CITY OF NORTH OAKS

Regular Planning Commission Meeting

Thursday, February 29, 2024

PLANNING REPORT

Figure 2- preliminary plans

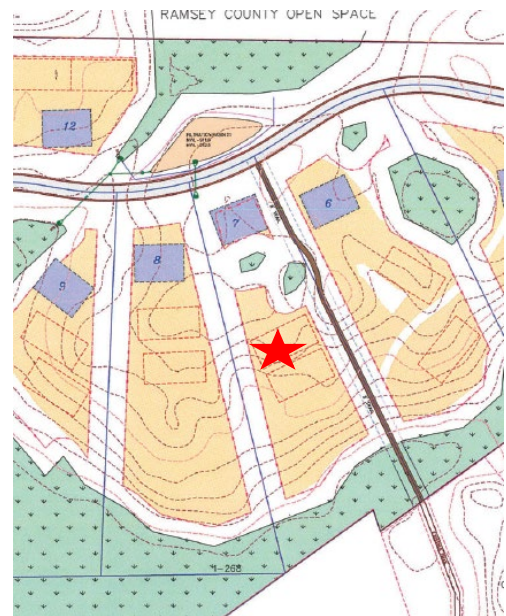
There are two wetlands on the site. The Code requires a 30-foot setback from the wetlands plus VLAWMO encourages a 30-foot wetland buffer. The Code also requires that driveways be 30-feet from the property line. The applicant did not request a setback variance but a setback variance is required to construct the house at the proposed location.

The approved plans for the East Preserve development showed the home site at the front of the lot, which would have eliminated the need for the driveway variance. It is the applicant's responsibility to show that the practical difficulties exist, and that the mandatory criteria for issuance of a variance are met, before the City Council could approve the required variance. Without a variance from the wetland setback requirements, the proposed house cannot be constructed as proposed.

Staff recommends that the Planning Commission continue this request so that the applicant can evaluate options for the lot, revise the plans to show two septic sites and either: 1) apply for a setback variance or revise the plans to comply with the required wetland setbacks.

REAR ELEVATION

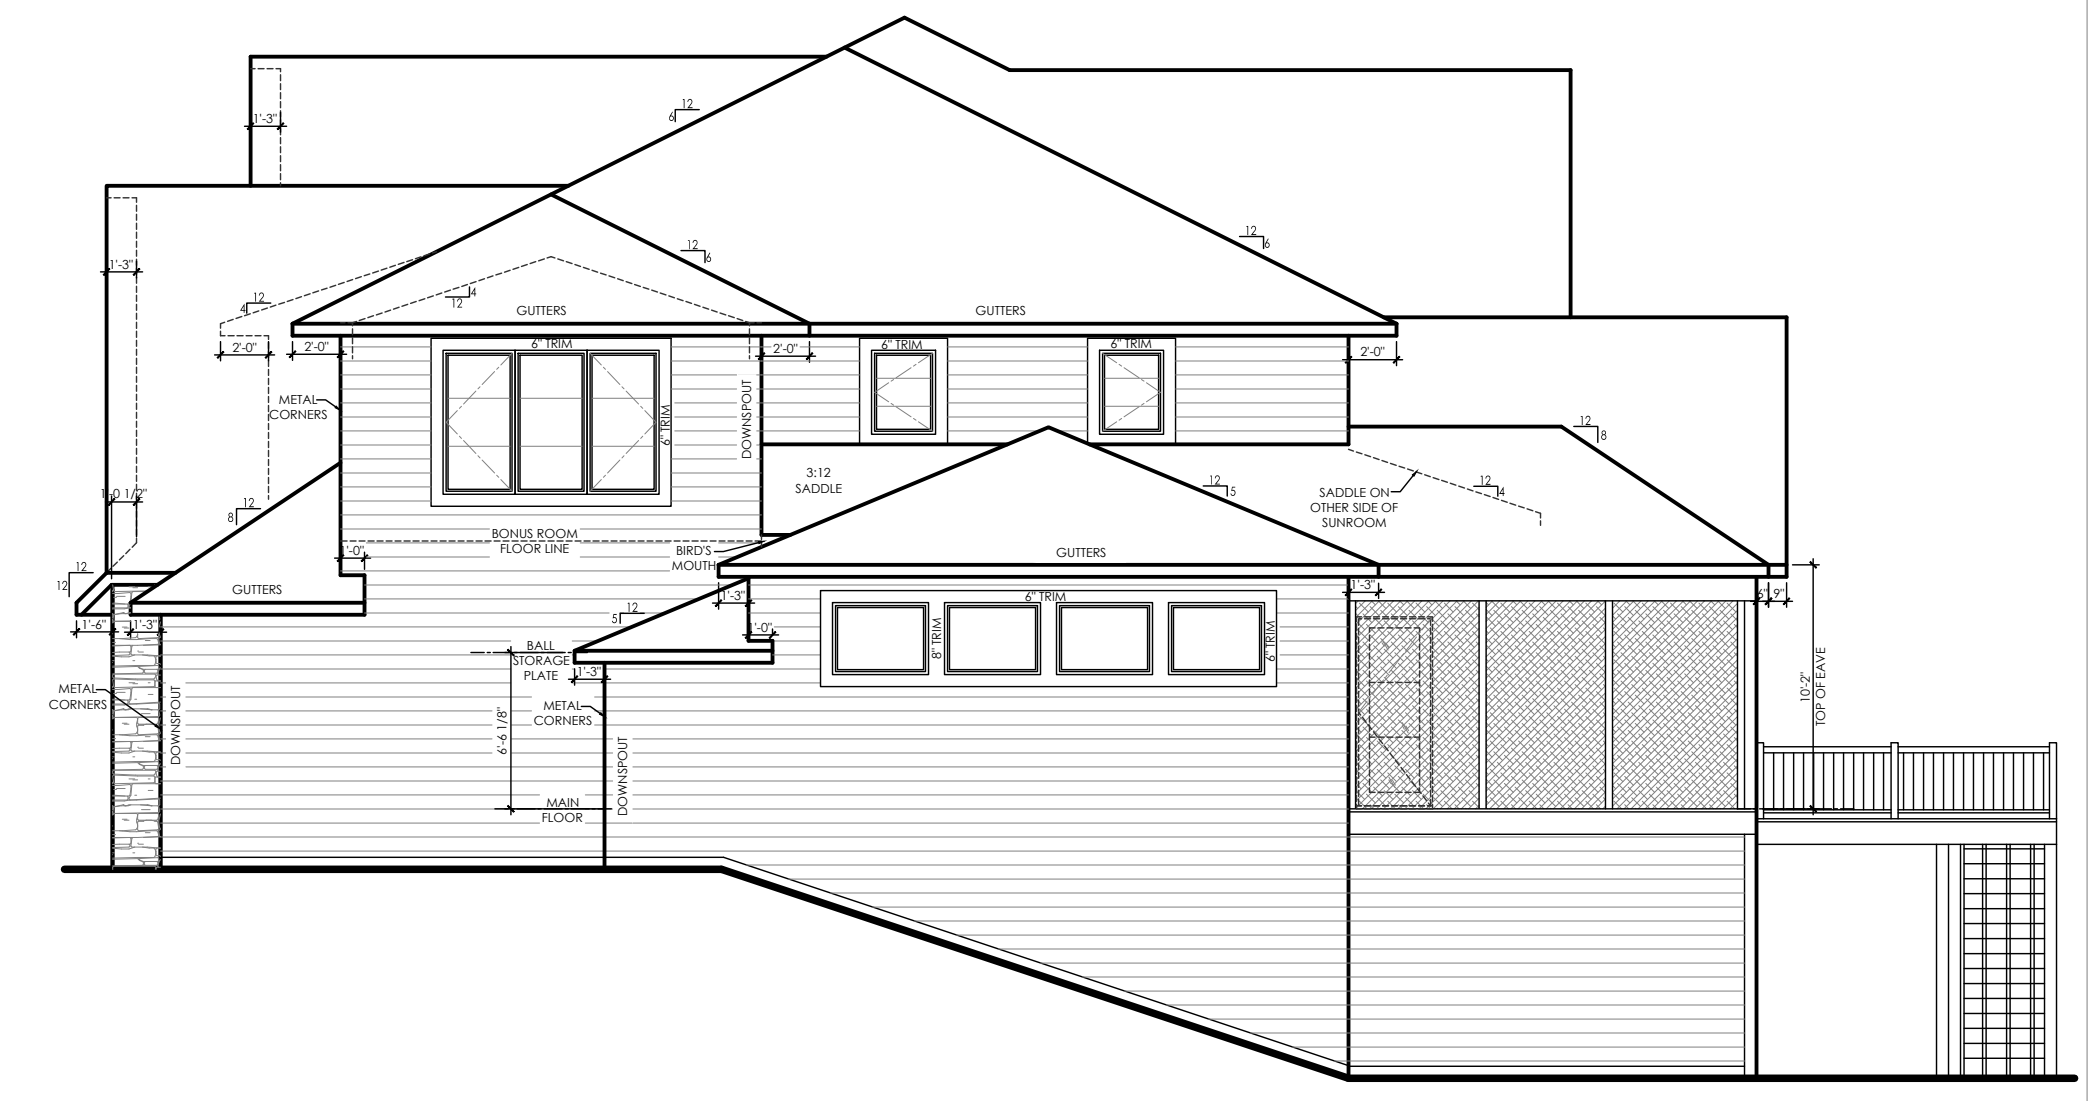
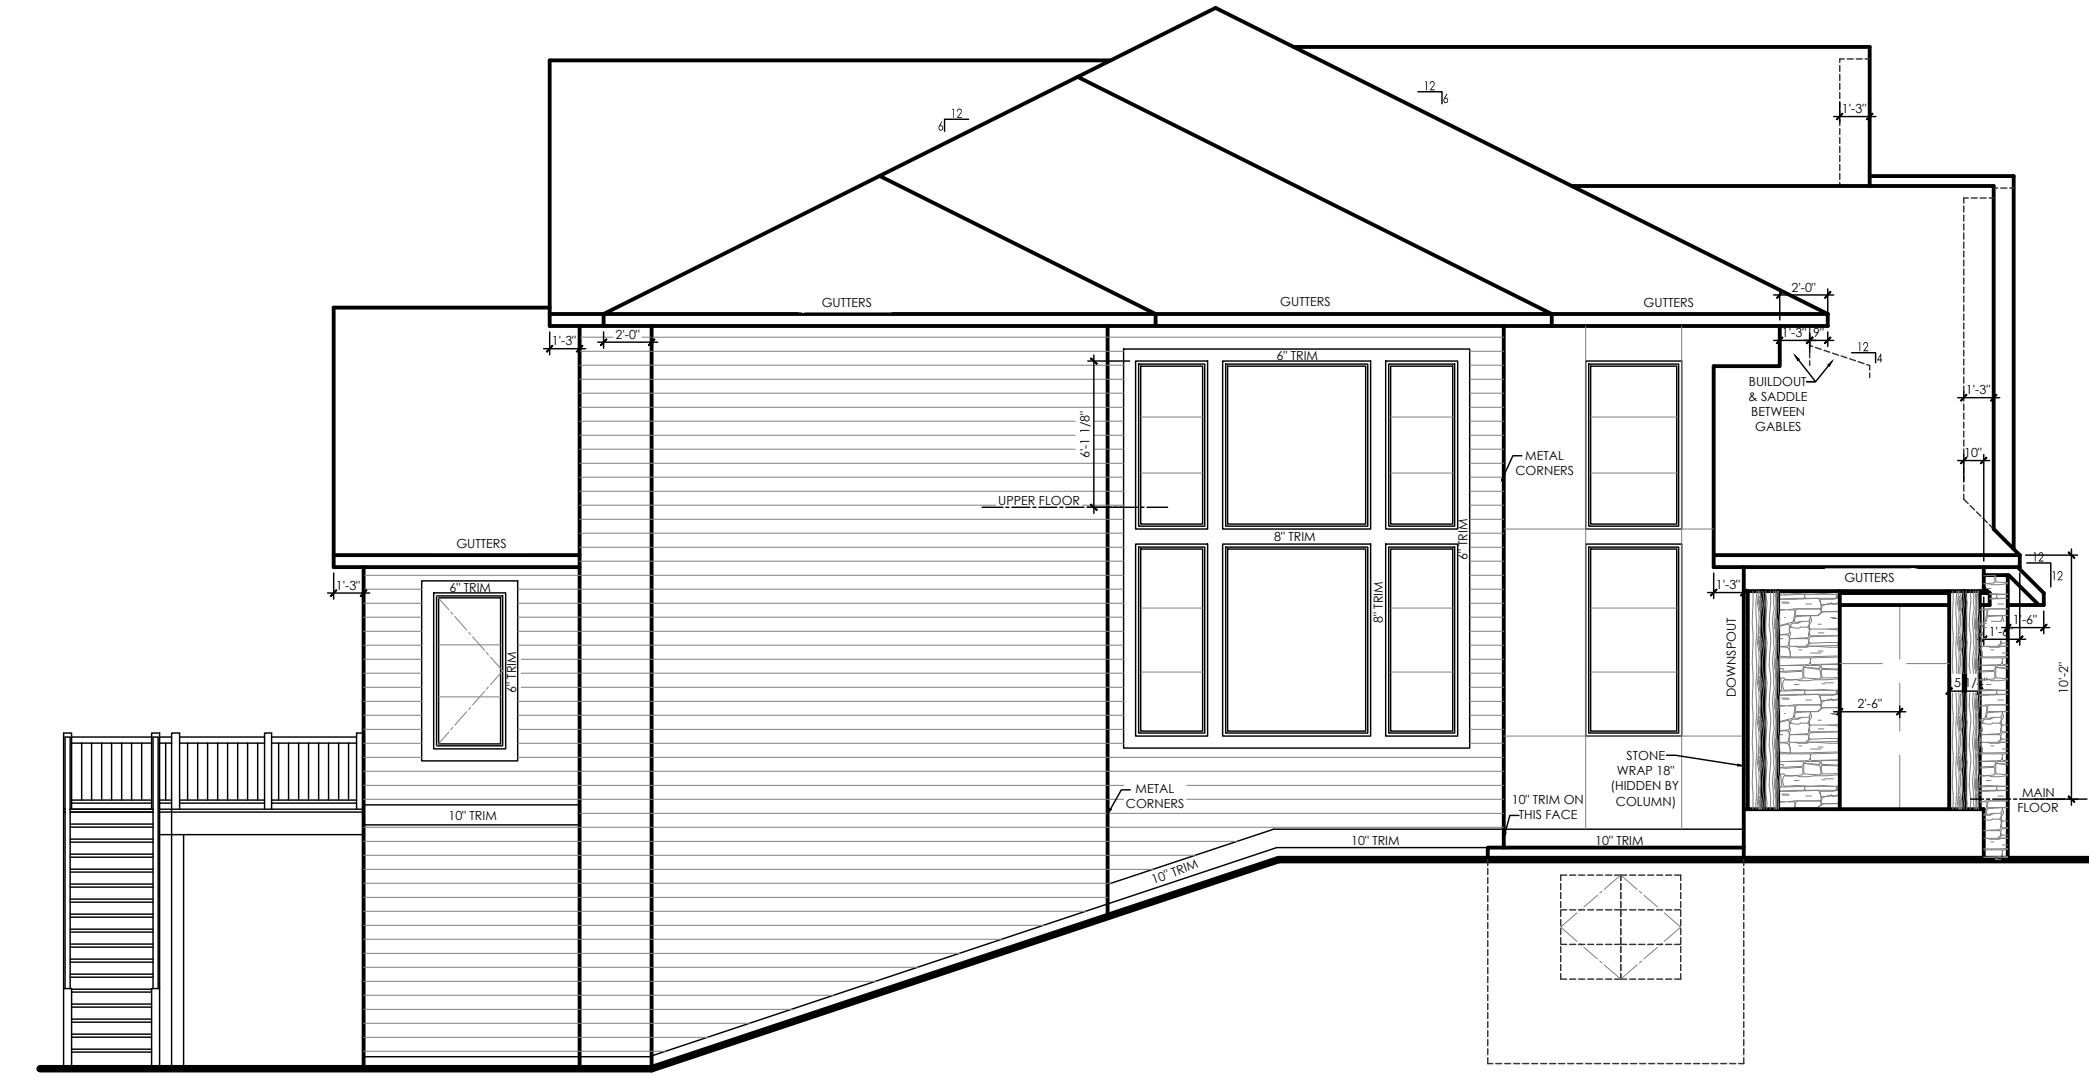
The applicant is requesting a CUP to allow the southern (rear) elevation of the proposed home to exceed 35 feet in height. Elevations provided by the applicant show the proposed home to be 44.2 feet in height along the side and rear facades. The front facade of the home is 34.9 feet in height. Building height is defined as the vertical distance from grade as defined herein to the top ridge of the highest roof surface in Section 151.005 of the Zoning Code.

The proposed front elevation is a maximum of 35 feet tall. The side and rear elevations are 44.2 feet in height. The increased height of the side and rear elevations requires a 50 foot setback from their respective property lines. The rear and west elevations comply with the additional setback standard. The east elevation is situated 42.2 feet from the east property line and must be setback an additional 8 feet. Plans shall be revised to comply with the required 50 foot setback from the side and rear elevations. There is space within the site to shift the building to the west in order to accommodate the additional setback.
